ORIGINATION FORM

Proposed Revisions to a Standard Plans Index

Index Number: 700-031

Index Title: External Lighting for Signs

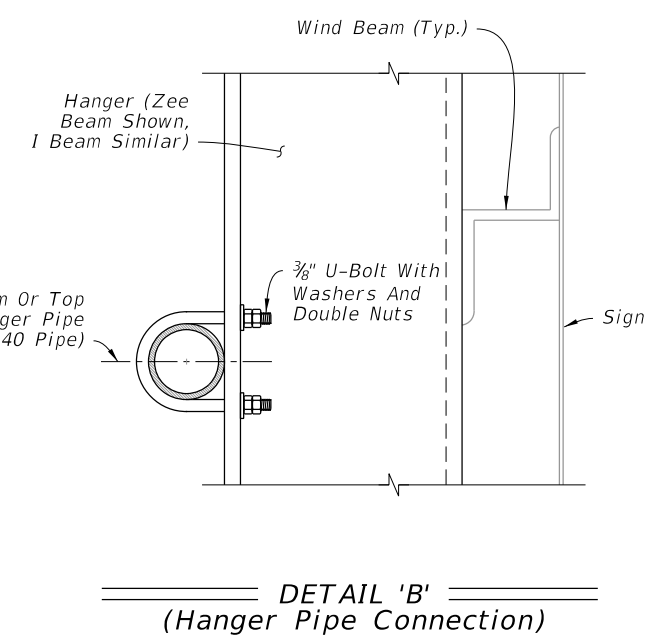
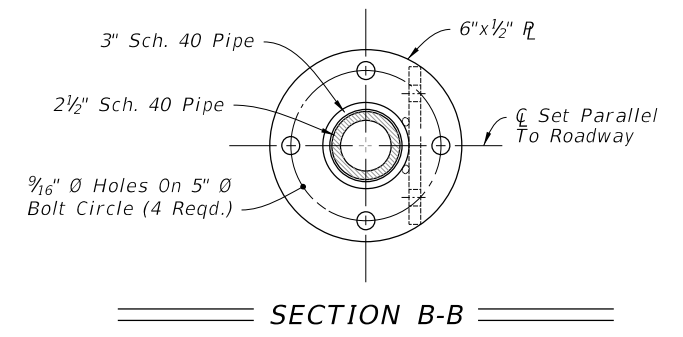
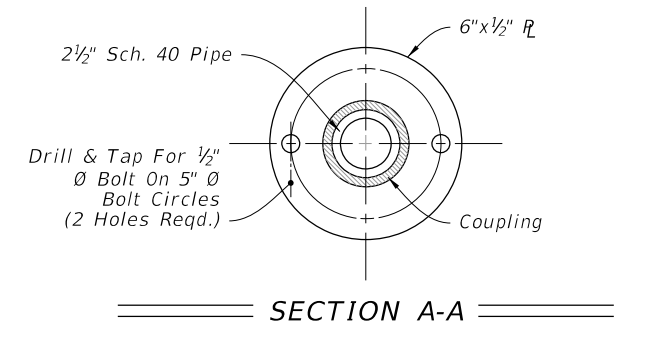
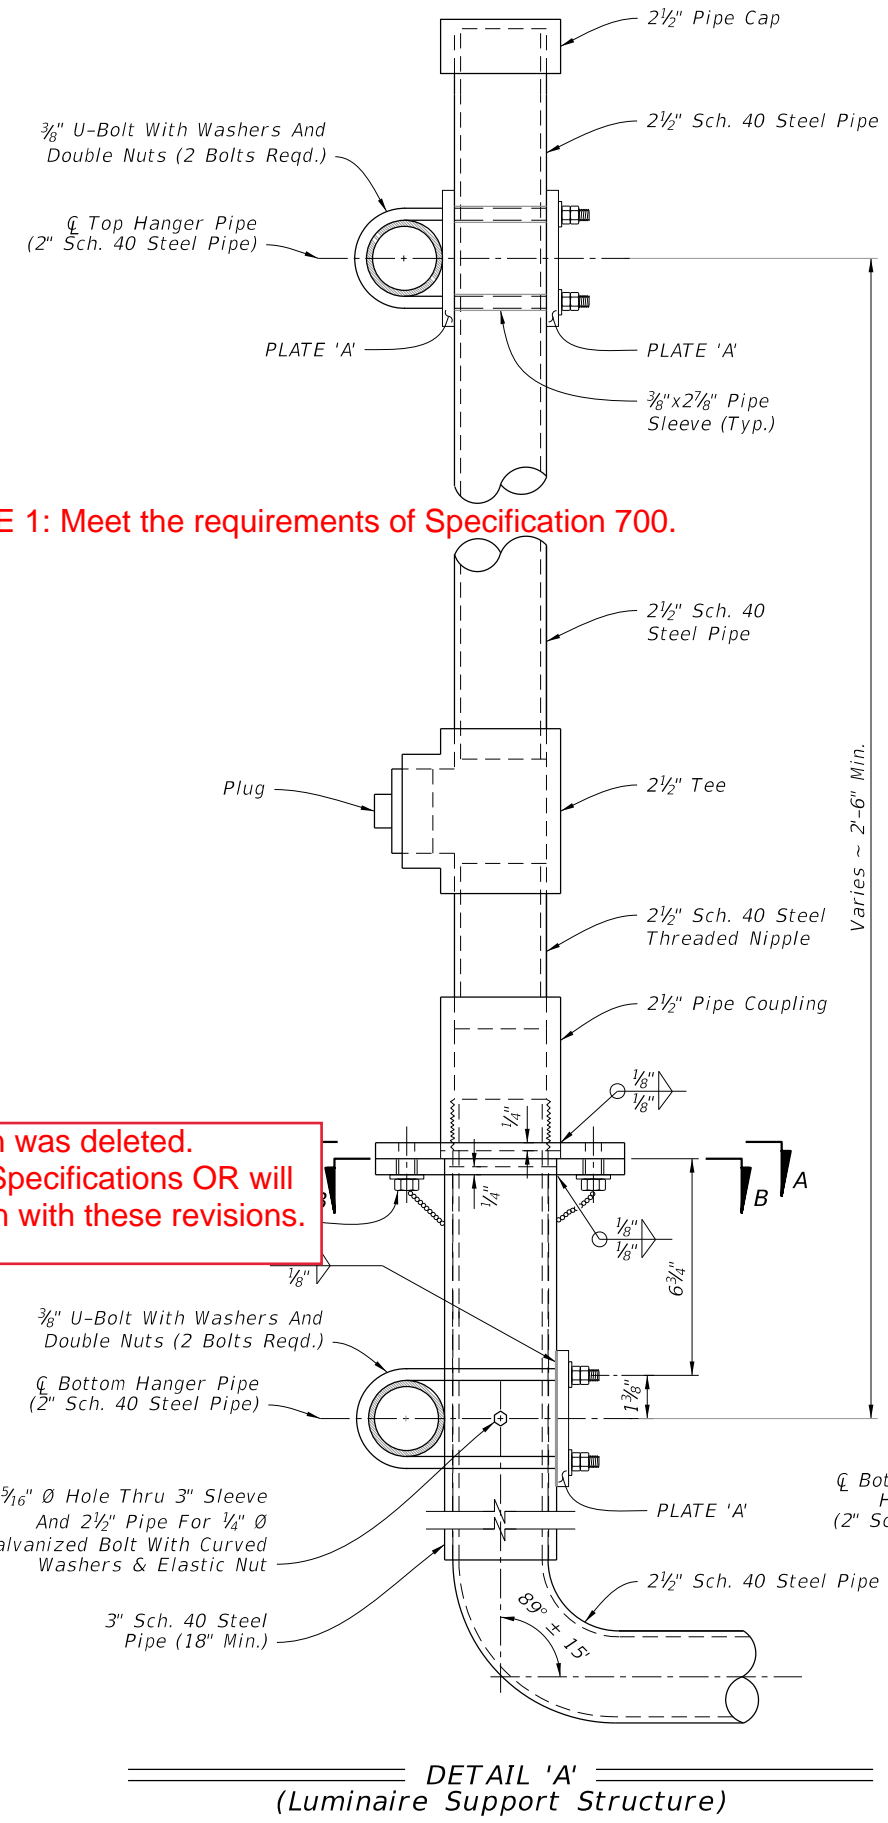
- ADDED NEW NOTE 1: Meet the requirements of Specification 700.**
- 1. NOTES**
1. ~~Install hanger pipe to each vertical beam crossed with a 3/8" U-Bolt, lock washers and hex nuts. Cap both ends of the horizontal pipe.~~
 2. ~~Materials;
A. Steel Pipe: ASTM A53 (Grade A or B)
B. Steel Plate: ASTM A36
C. Bolts: ASTM A307
D. Hex Nuts: ASTM A563
E. Washers: ASTM F436~~
 3. ~~Coating: Hot-Dip Galvanize pipes, plates, structural shapes: ASTM A123. Fasteners and hardware: ASTM A153.~~
 3. ~~All pipe dimensions are NPS.~~
 4. ~~Chord O.D. + 5" (Min.)~~

GENERAL COMMENT: Some material information was deleted. Information is either already covered in Standard Specifications OR will be added to Section 700, 962 or 965 in conjunction with these revisions.

Added Note 1 - "Meet the requirements of Specification 700"; Deleted Note 2 and 3; Renumbered Notes.
